Board identification

This errata sheet applies to some samples of the STMicroelectronics STEVAL-STLKT01V1; see the below information for details.

Order code	Device Info
STEVAL-STLKT01V1	1624 (on the STEVAL-STLCR01V1 evaluation board)

Figure 1: Board identification (1624)

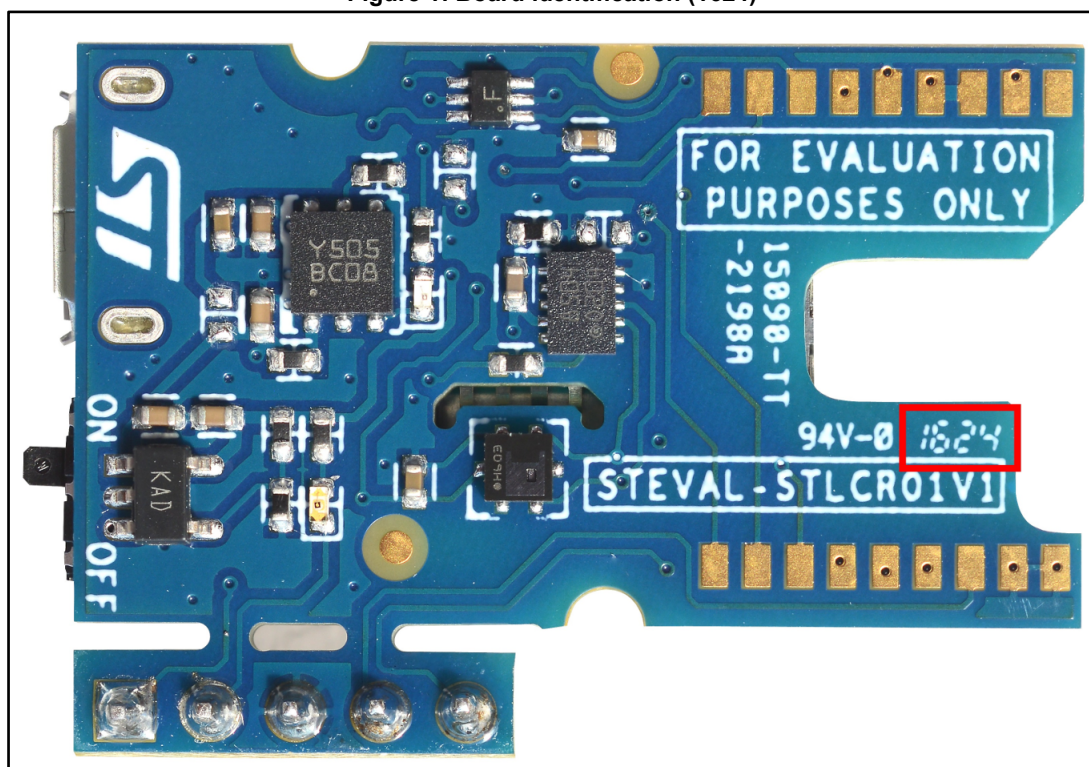
The current sensing feature not available on the STEVAL-STLCR01V1 SensorTile Cradle production lot “1624” (see [Figure 1: "Board identification \(1624\)"](#)); the CG pin of the STC3115 is not connected properly in this lot.

None.
